# CITY OF ALBUQUERQUE

**Re: GAHP Casa Feliz  
523 Espanola Street SE  
Request for Permanent C. O. – Not Accepted  
Engineers Stamp Date 12/18/15 (L19D073I)  
Certification dated: 7/12/2017**

PROJECT TITLE: GAHP Casa Feliz (L19D073G H, I)  
DRB #: \_\_\_\_\_ EPC#: \_\_\_\_\_

SECTION A-A

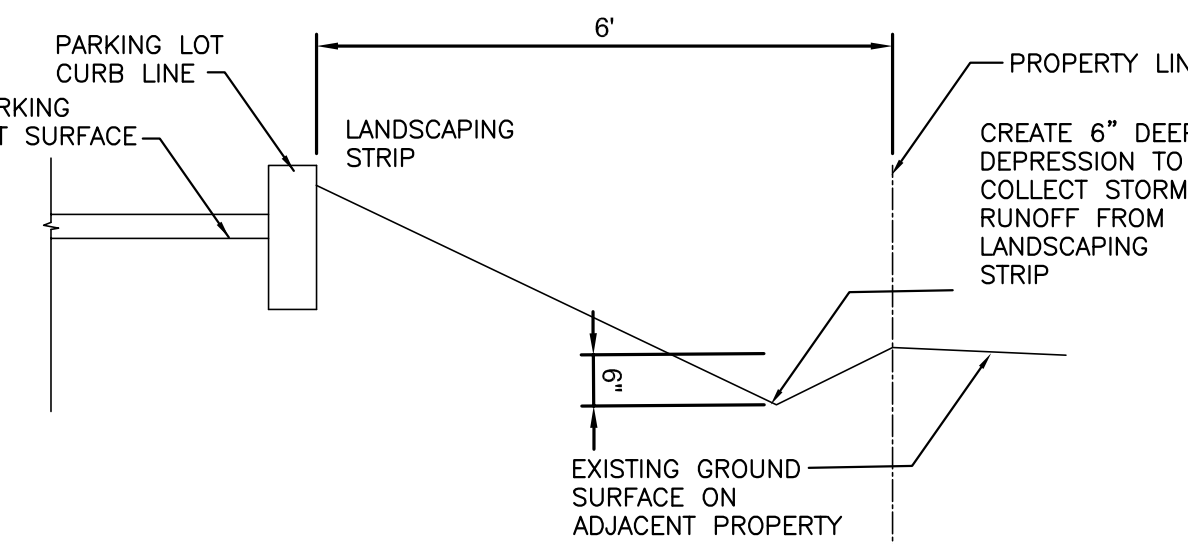
- Section AA has not been graded according to plan and cannot be graded according to plan without the addition of a retaining wall along west edge of the site. Two wooden fences retain about 2' of dirt (not allowed) and the 6" deep swale that is supposed to prevent cross lot drainage is missing.
- The original topo did not reflect all of the grade change from the parking lot to the adjacent property. A new survey is needed to measure the grade accurately, then the Grading Plan must be revised and resubmitted to hydrology to include a design of a wall along the west side of the site as necessary to prevent cross lot drainage.
- The revised plan should include a new engineer's stamp date.
- The revised Grading and Drainage Plan must include a detailed cross section from the parking lot to the existing grade on the adjacent lot.

After the revised G&D Plan is approved by Hydrology and the contractor has completed the construction, a new Engineer's Certification should be submitted to hydrology for CO. The following should be on that plan.

1. As-built survey information should be added to the plan to include spot elevations throughout the parking lot, the swale , and the finished floor elevations as well as the top of the new wall to be added on the west side of the property.

A1 ENLARGED SITE DRAINAGE PLAN - BUILDING J

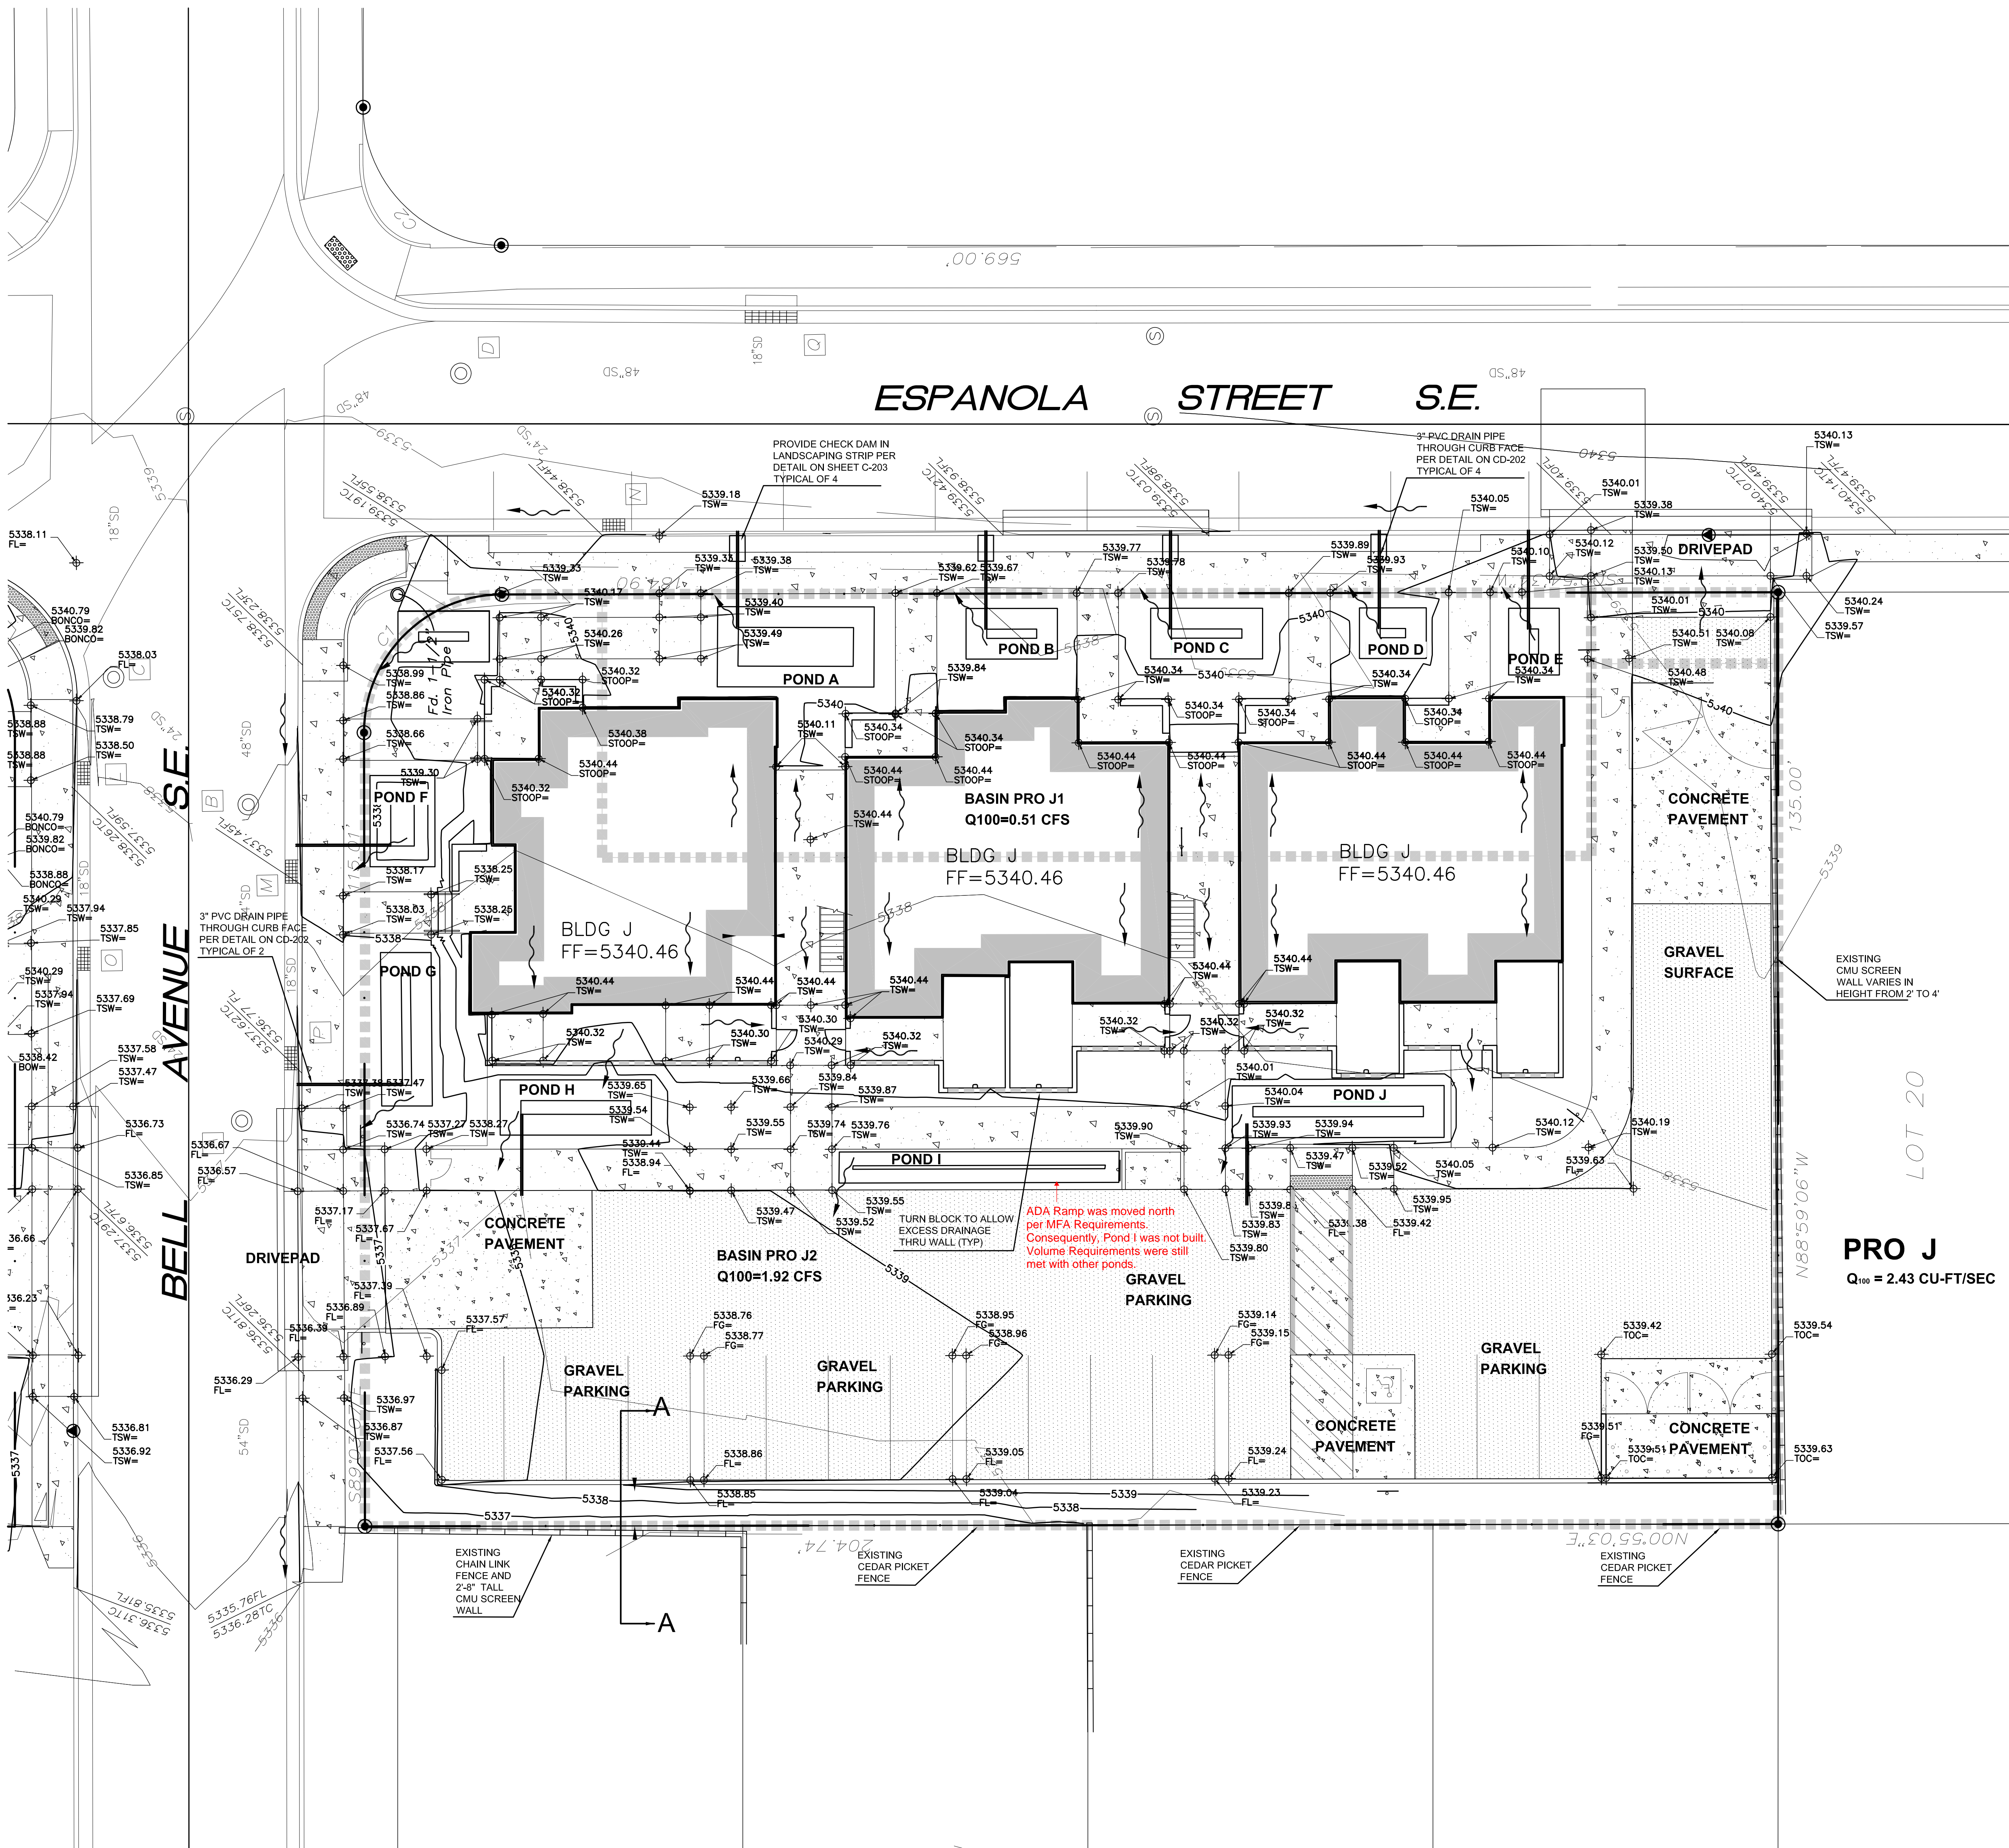
The Greater Albuquerque Housing Partnership is aware of your concerns regarding the rear yard slope of our Casa Feliz development, specifically Building J located at 511 Espanola St SE 87108.

We understand the disapproval letter was connected to Building K at 523 Espanola St SE, but it was actually tied to Building J at 511 Espanola St SE. We request your reevaluation of Building K for the release of a permanent Certificate of Occupancy.

Please consider this letter a commitment to work with the Design Engineer and the City of Albuquerque Hydrology Department to resolve this issue to your approval, allowing up to 60 days for an appropriate solution and completion of the task.
